Subject: Forward calorimeter

Subject: Hole geometry  
Posted by [StefanoSpataro](#) on Thu, 14 Jun 2007 15:49:33 GMT  
[View Forum Message](#) <> [Reply to Message](#)

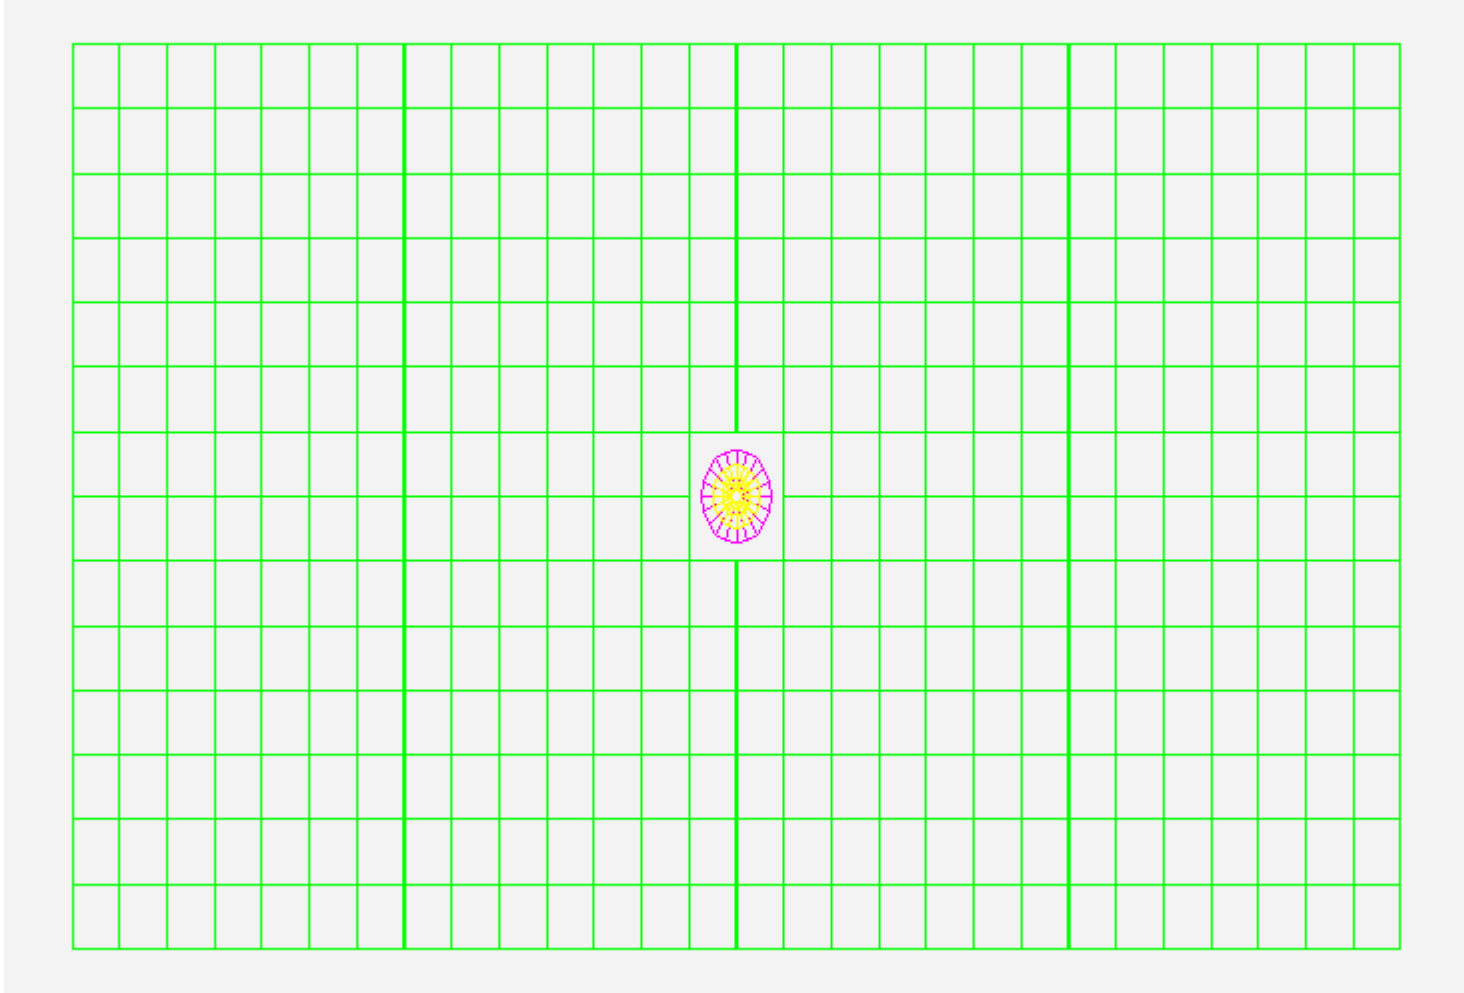
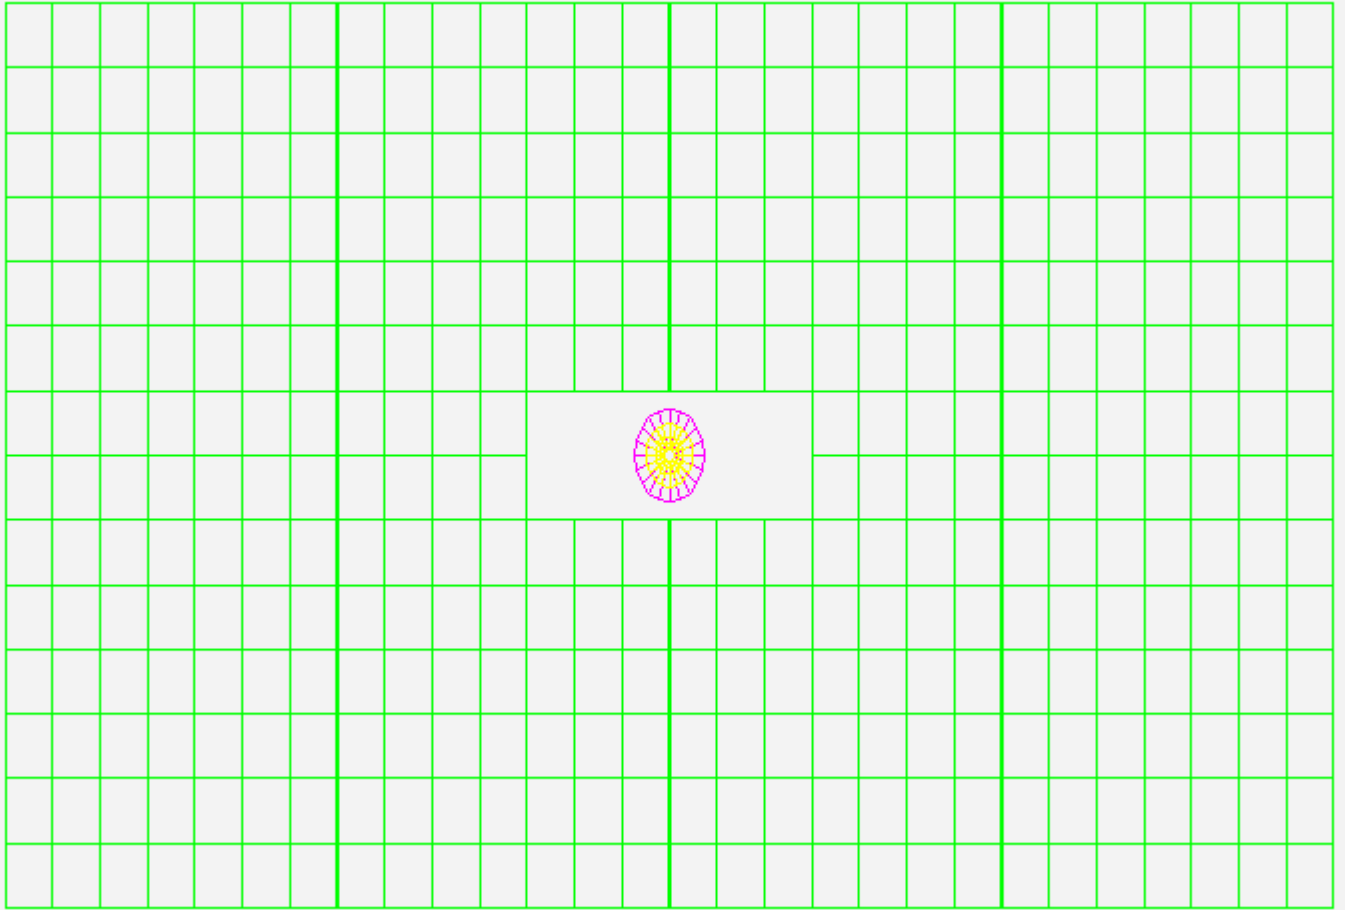
Hello,  
I found maybe one "bug" in the createGeometry.C, thus in the geometry of the fsc.

I suppose the geometry is defined as the "Chicane" option. Here the position of the hole along X is centred at hole\_xpos = -120.0 [mm] and not at 0.

But when the "crystals" belonging to the hole are rejected, I found:

```
if(TMATH::Abs(curShift.X ()-hole_xpos)<hole_xsize/2+cellxsize/2 && ...
```

In this case the rejected area is from -12 cm to +12 cm, thus we reject 6X2 pads. This is not so clear to me, maybe the TMath is not needed there.

In each case, actually in PandaRoot we have the "straight" pipe, so the "hole" is the fsc region should be around 2X2 cm<sup>2</sup>, thus only 2X2 pad missing.

I created one geometry file with this kind of setup, but before committing it I would like to ask confirmation from the experts.

Just to show the differences.

This is the actual geometry inside svn:

This is what I have, reducing the hole:

(green in the fsc, magenta in the pipe in the target region, yellow is the pipe in the forward (fsc) and backward region).

As for the geometry, in particular the location and the dimensions of the hole, I still believe that my implementation was right.

I looked into the geometry created with my old macro (still in the release 785). The picture looks differently from what you were showing, because the hole was not central!

Moreover, the rejected area is not, as you write, from -12 cm to +12 cm! The formula suggests

that the gap in X is  $\text{hole\_xsize}/2$  ( because  $2*\text{cellxsize}/2$  is occupied by crystals adjacent to the hole) and is centred in  $\text{hole\_xpos}$ . I do not see what is wrong with it.

The number of rejected crystals depends on the hole position and its size, which were the macro parameters. If you set the  $\text{hole\_xsize}=200$  and  $\text{hole\_xpos}=0$  you should get exactly the picture which you are showing as the second one. I assumed the chicane option because I wasn't aware that we only have the straight beam pipe implemented. However, as the chicane is the default solution right now, we'll have to work on implementation of it, too.
